## **Addendum #4**

Knott County Transit Facility Rehabilitation and Parking Deck Construction  
31 Justice Center Drive  
Hindman, KY 41822

## ADDENDUM #4

Project: Knott County Transit Facility Project, MGA # 1707  
Date: March 22, 2019  
Issued by: Allender Contarino, Assoc. AIA – [allender@murphygroupky.com](mailto:allender@murphygroupky.com)

F1 UTILITIES LAYOUT FOR KNOTT COUNTY TRANSIT CENTER  
N.T.S.

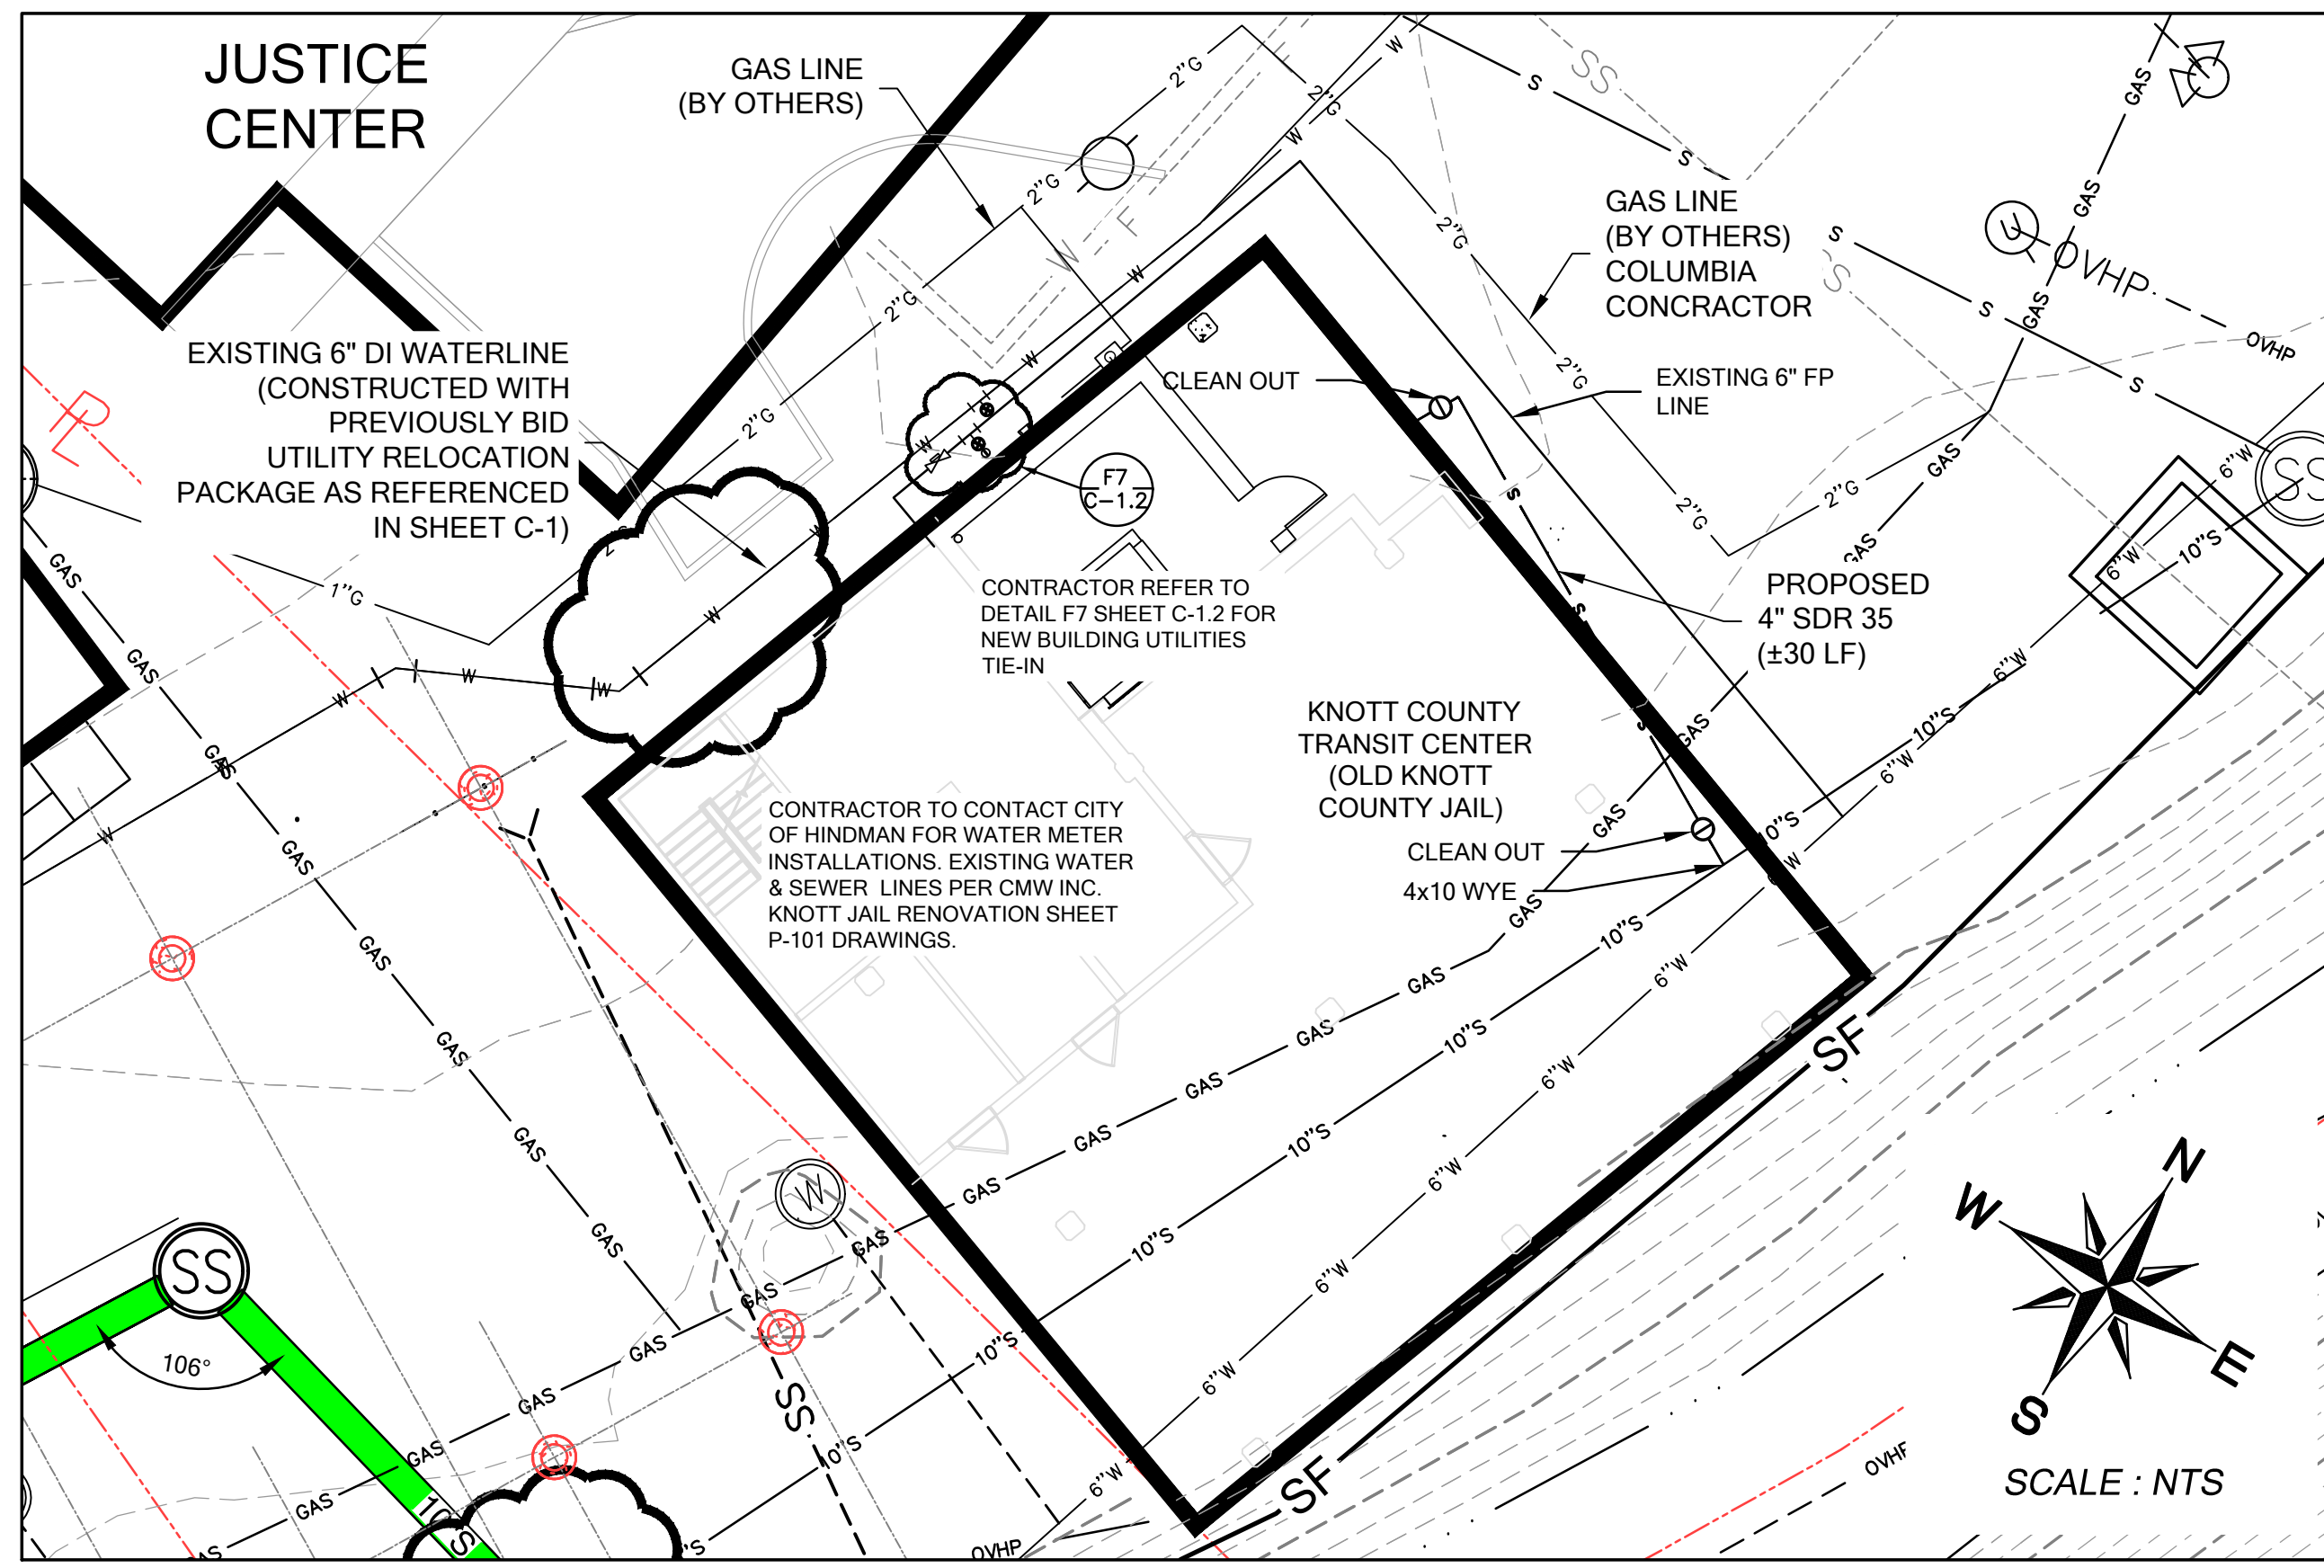
Answer: SDR 17 PVC is acceptable.
- ii. Detail F1 notes to Relocate 6" DI Water Line. (Is this an old note from the previous bid or part of this bid? It is noted to the right of this same detail as a 6" Existing Fire Protection Line, which would have to be relocated by a Sprinkler Contractor. Please clarify.)

Answer: Sheet C-1.2 is noted as being FORE REFERENCE ONLY (Bottom right corner of sheet).
- iii. The 4" Sewer is shown to connect directly into the city's 10" Sewer pipe. (Will the City of Hindman allow this or will there have to be a New Manhole set? Please clarify.)

Answer: City of Hindman will allow – please note a 4" clean out is included with the 4"x10" wye fitting - see revised Detail F1/C1.2
- iv. Spec section 00207, which is Federal Requirements, note #2 says this project is Buy America Requirements. However HVAC sheet H5.1, note #21 on the VAV schedule as well as other HVAC equipment calls for Buy American. Please clarify which requirement pertains to this project and bid. Huge difference in pricing and availability of material.

REVISIONS		
Δ	DATE	NOTES
1	3-22-19	Add notes to F1 for Add #4
